## **Work Variance Request Form**

Groundwater Remedy Phase 1 Construction, PG&E Topock Compressor Station, Needles, California

PG&E TOPOCK GROUNDWATER REMEDIATION PROJECT	
Work Variance Request #2 – Relocate tie-in point for tempo	rary remedy construction water line
Request Prepared By: PG&E	Request Approval From: DTSC and DOI
Date Submitted: 7/31/18	Date Approval Required: August 2018
Variance Request No.: 2	Map Area: N/A
Location: New tie-in point is aboveground and inside TCS	
Landowner/Land Manager: PG&E/HNWR (managed by USFW	/S) Land Owner Parcel No: 650-161-08/650-161-12
Current Vegetative Cover/Land Use: Minimal along Pipeline 3	300A access road, none at the new tie-in point inside TCS
Existing Sensitive Resource?  No X Yes, Specify: Palo ve	rde plants along Pipeline 300A , Rout 66 Welcome sign
Variance From:	/Procedure Response to Comments
X Drawing Permit Condition	Other
<b>Detailed Description of Variance and Justification</b> (Attach ac	Iditional information if necessary):
Attachments: Photo X Construction Drawing A	erial Photo Mark-Up Correspondence Other

## Revised Drawings for Work Variance Request #2

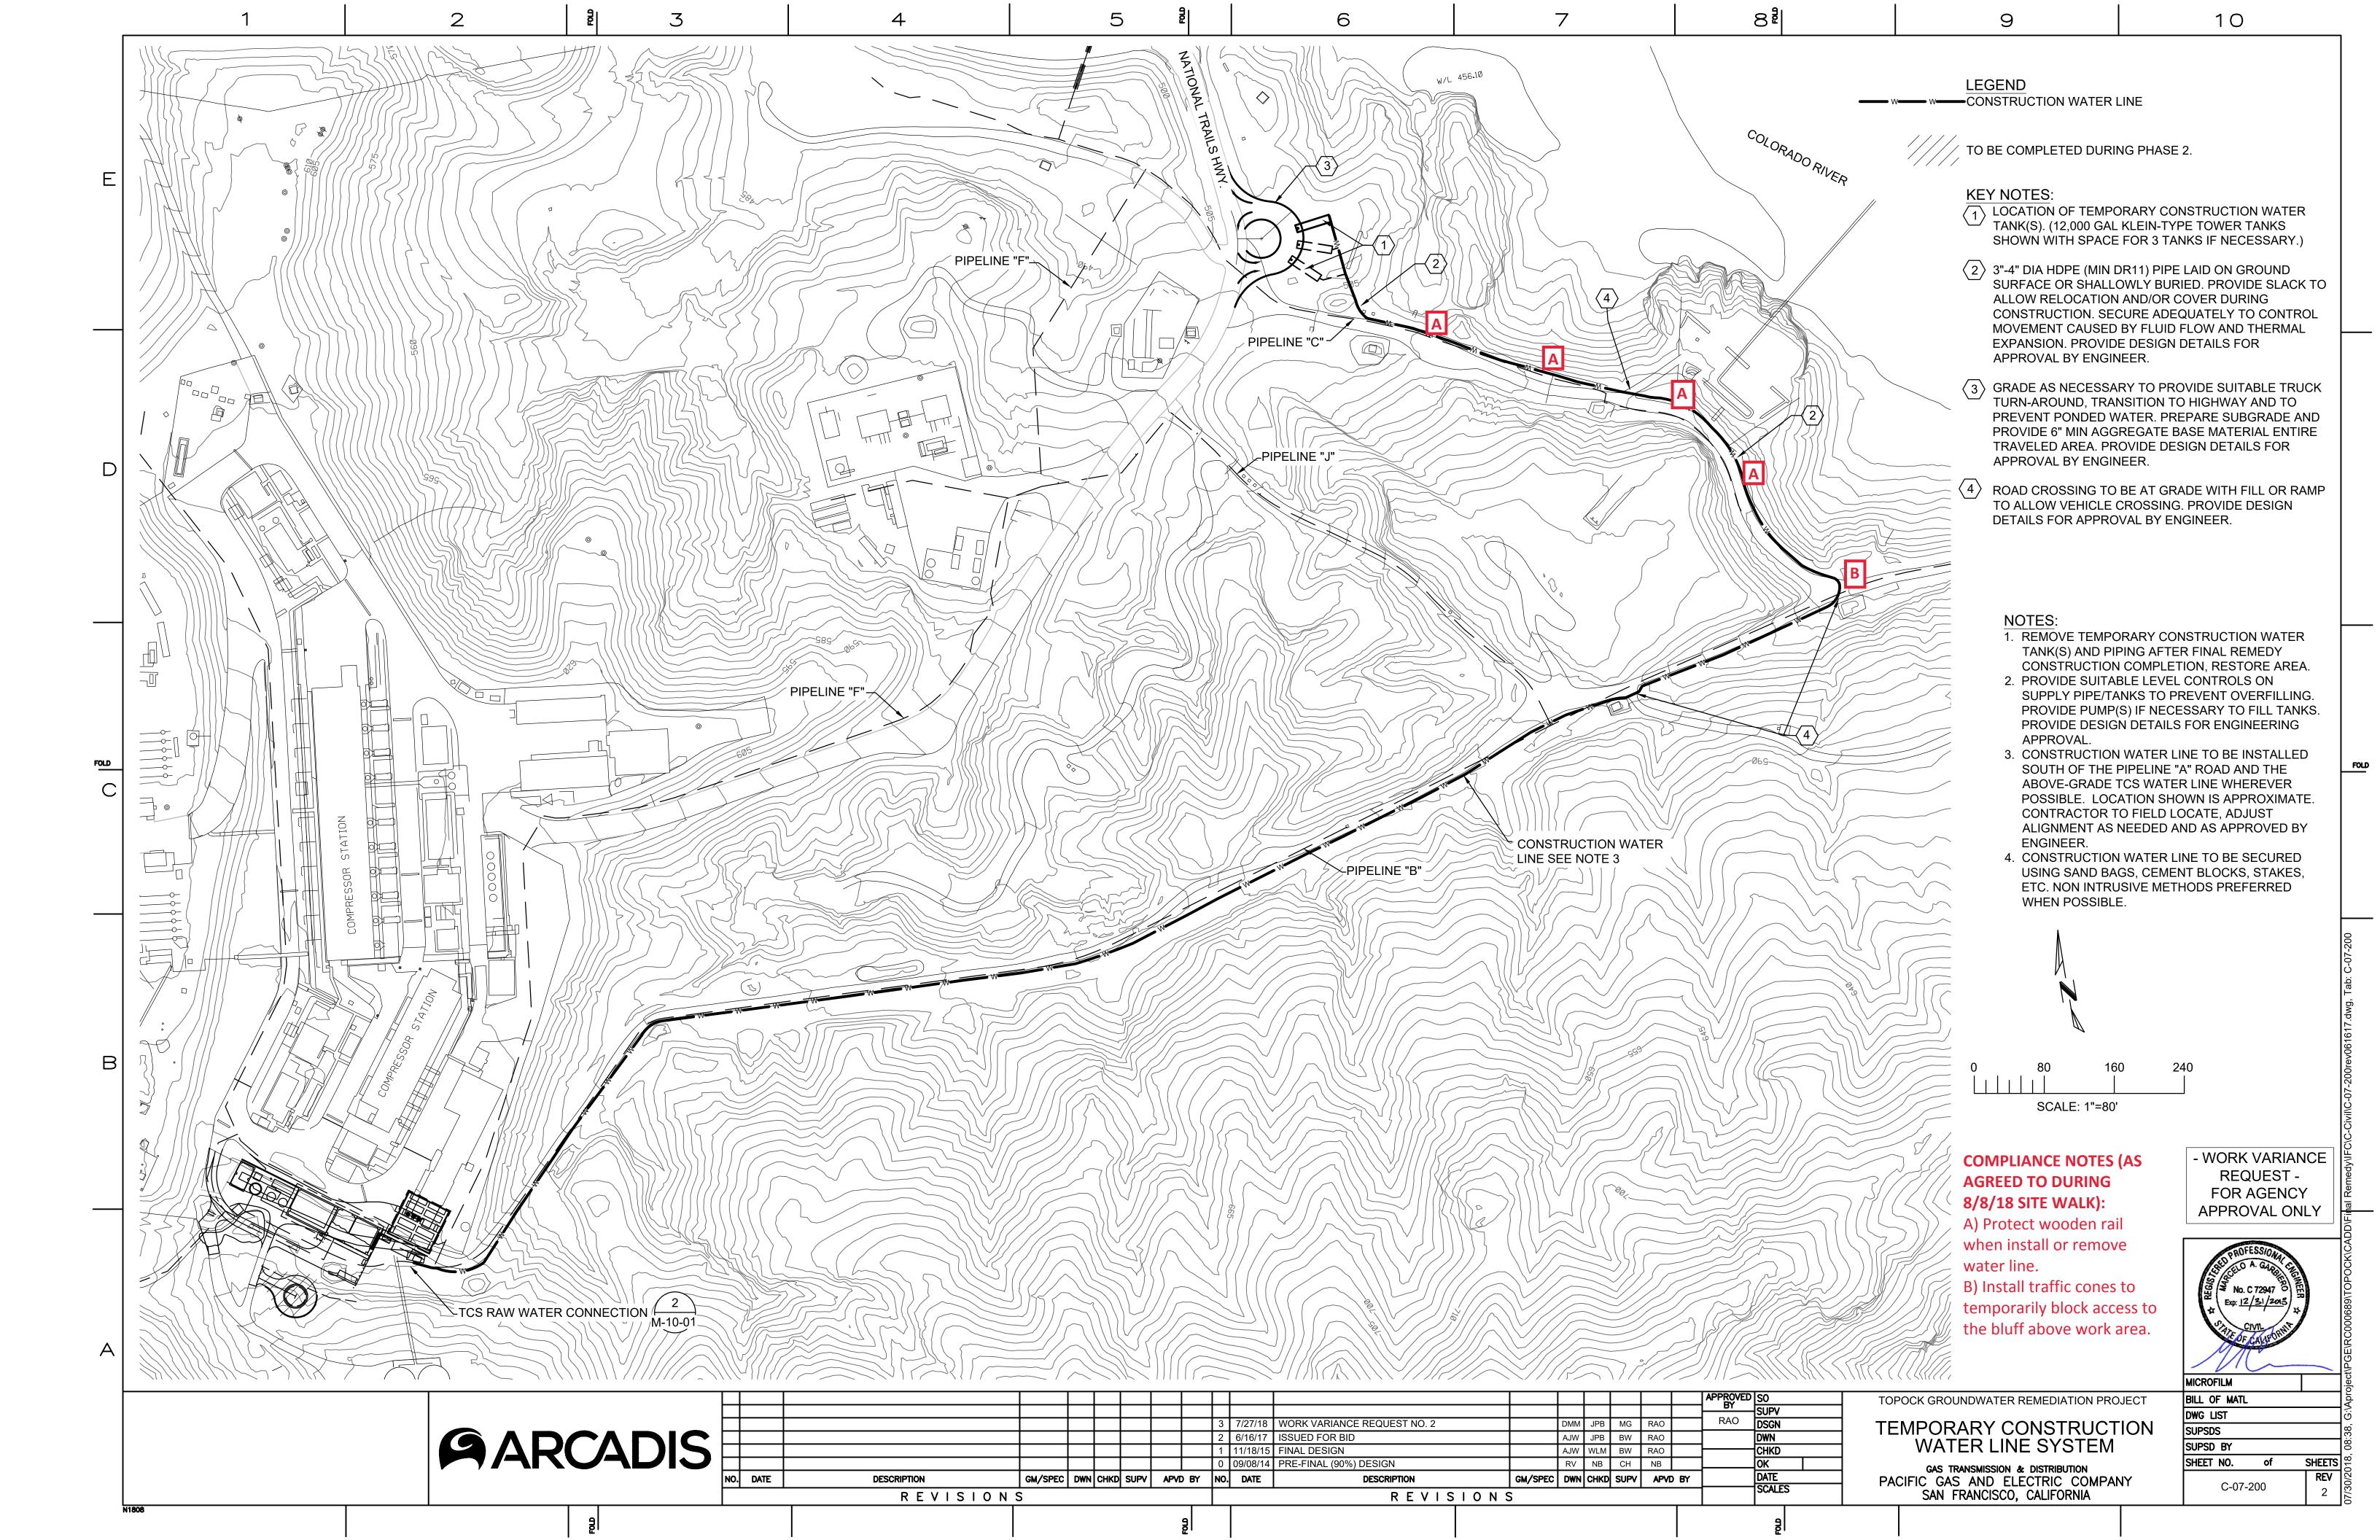
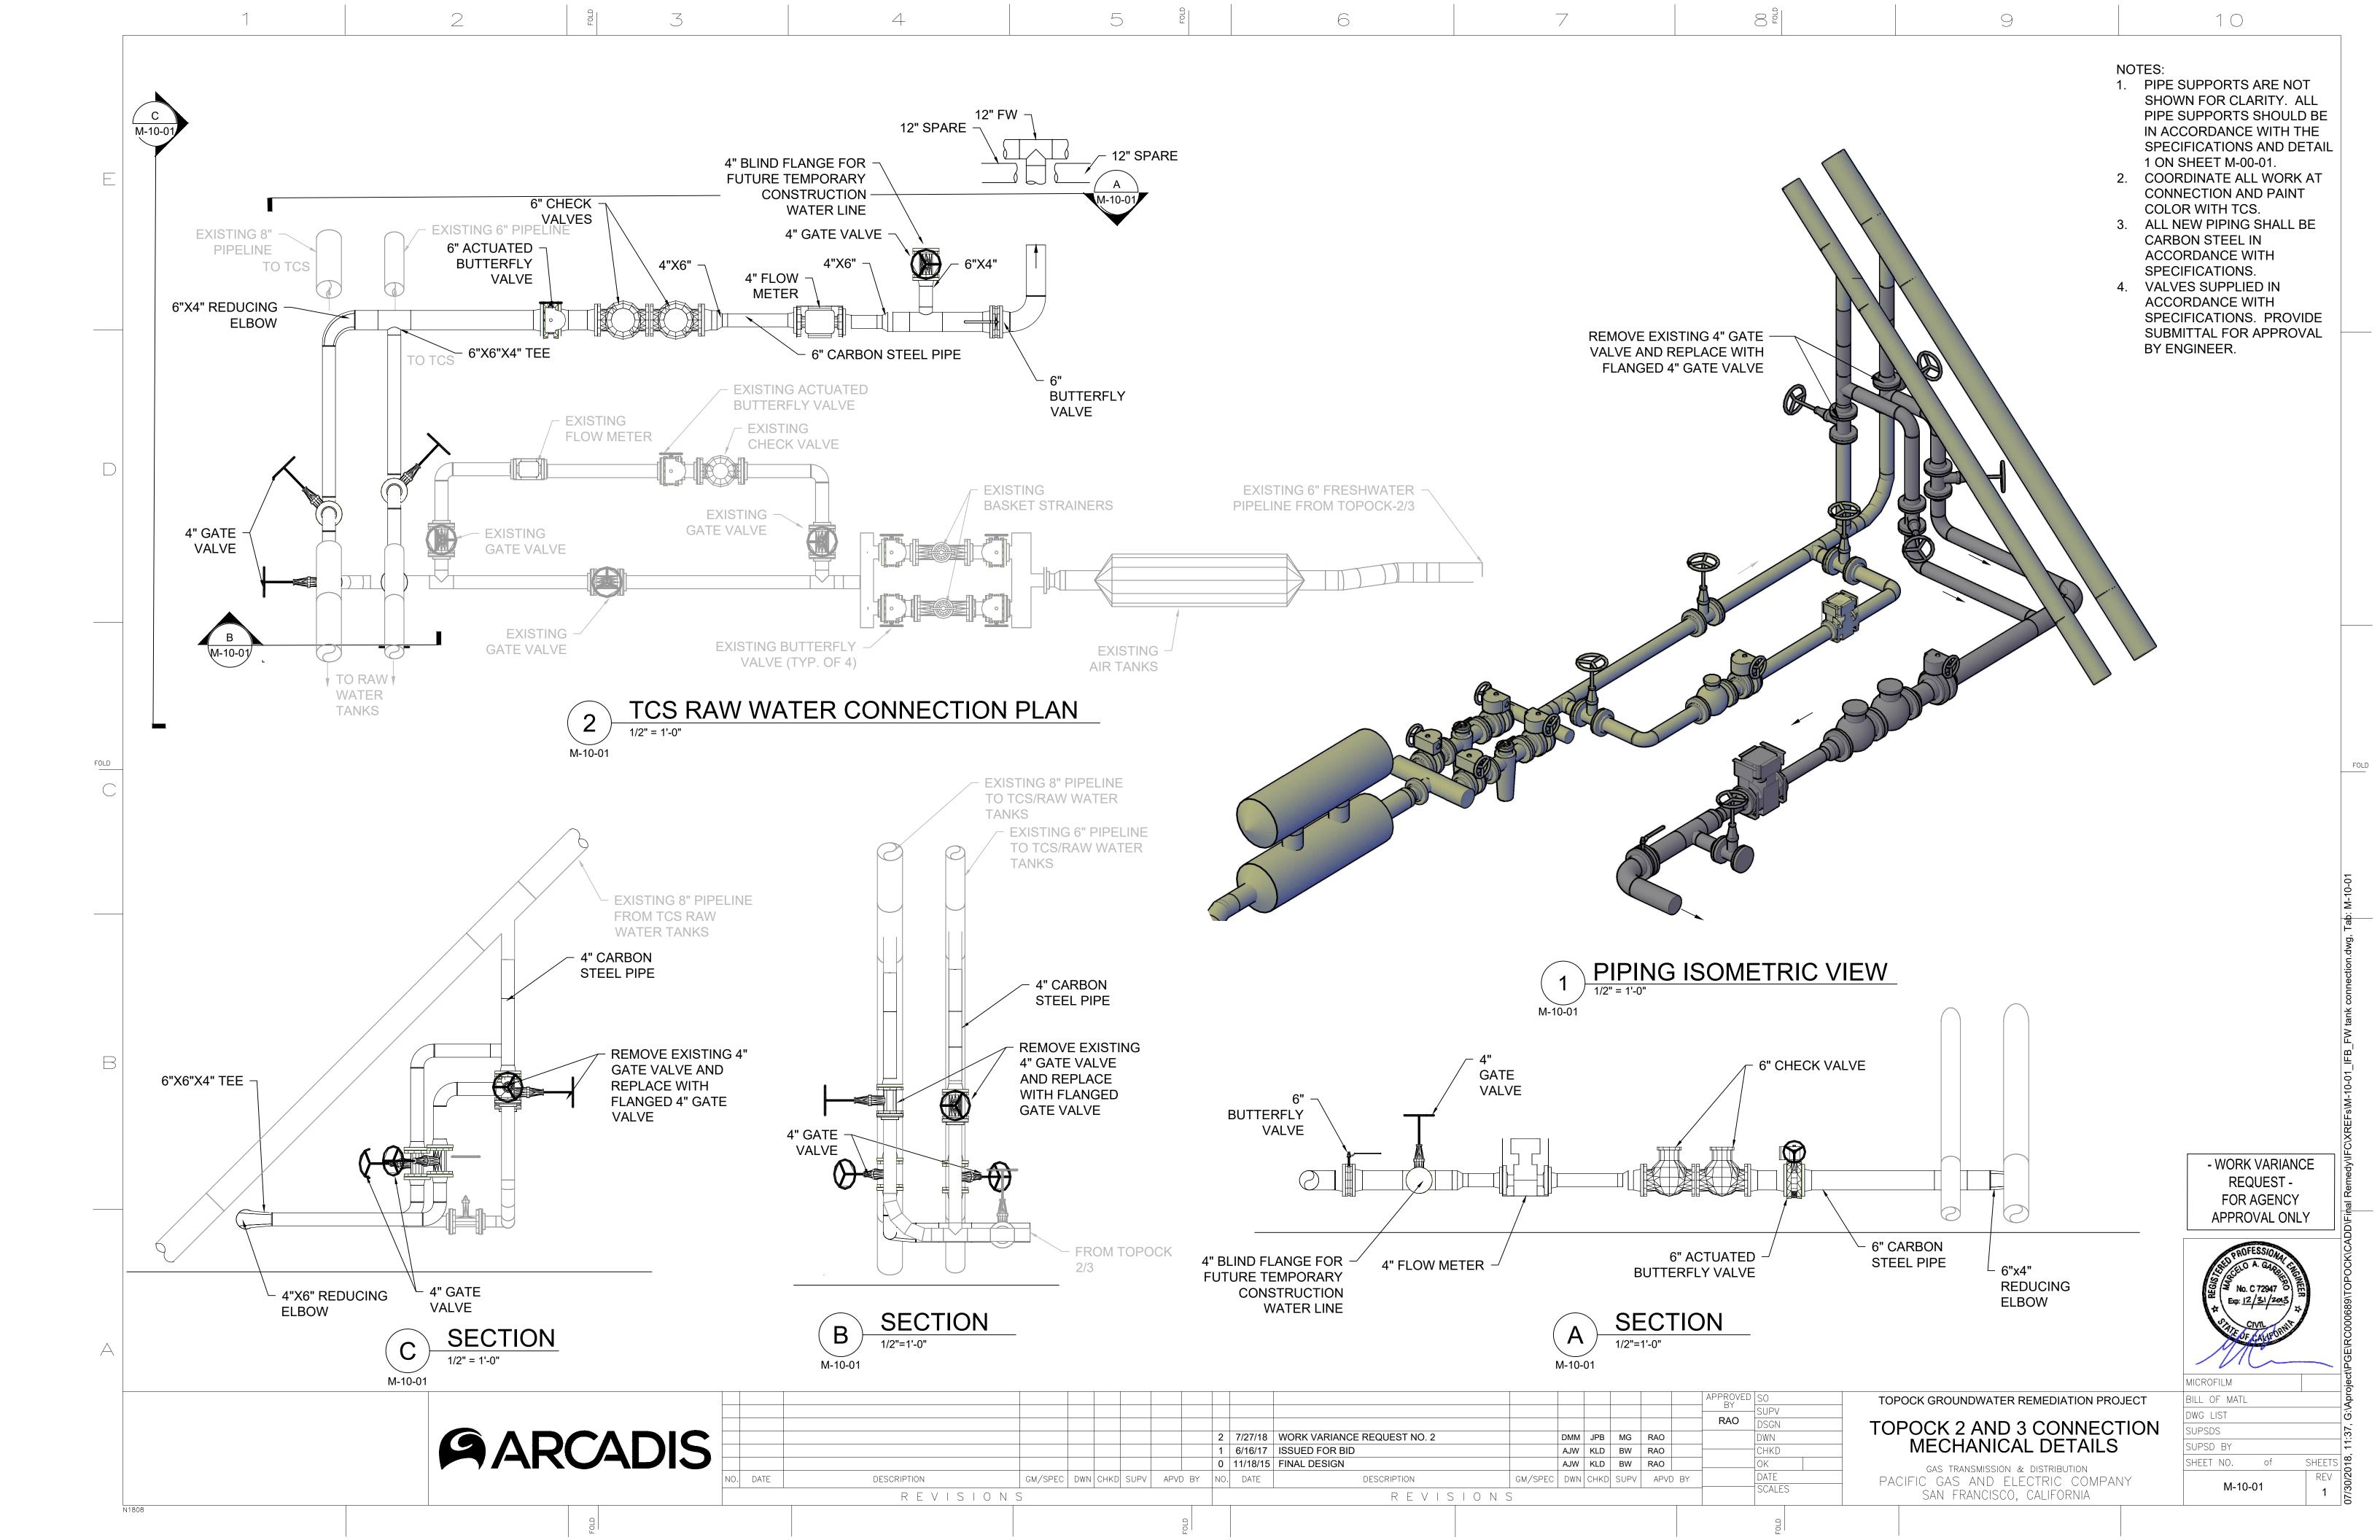
Potential Impacts of Variance:	
X Air Quality (During construction) Hazardous Mate	erials X Aesthetic (During construction)
X Biological Resources (Transplant one X Noise (During constr	uction) Water Resources
young palo verde plant along pipeline road) Soils Paleo Resources	
Cultural Resources Hydrology and V	Vater Quality
Description and Justification:	
The tie-in point for remedy construction water will be moved Compressor Station and below the TCS Water Storage Tanks. damaging the existing pressurized 6-inch water line and to av the Station's water supply. This work variance request addres	PG&E proposes this relocation to eliminate the risk of oid any interference with PG&E Gas Operations control of
<ol> <li>Relocate the construction water tie-in point to an above inside TCS – The final design calls for the temporary const water line just as the line turns southwest to continue to aboveground valve manifold, located below the TCS Water Provided Provided MA 10,013.</li> </ol>	truction water line to hot-tap into the existing 6-inch steel TCS. PG&E proposes to move the tie-in point to an

- Revised Drawing M-10-01).
  - This relocation reduces the risk of damaging the existing pressurized water supply line and avoids any interference with PG&E Gas Operations control of the Station's water supply. This also simplifies the overall field activity by eliminating the need to coordinate with Southwest Water, the water purveyor. All field work associated with the tie-in will be done aboveground.

- 2. Extend the temporary construction water line to the new tie-in point, along Pipeline 300A access road The planned 4-inch HDPE temporary construction water line will be extended, following the route of the Pipeline 300A access road, to the new tie-in point inside TCS. This pipeline extension is approximately 1,950 feet and is also made of 4-inch HDPE (see Revised Drawing C-07-200). The pipe will be laid on ground surface and to the south of the 6inch water line where possible. At the crossing with SoCal Gas pipeline access road, the pipeline will be at grade with fill to allow for vehicle crossing.
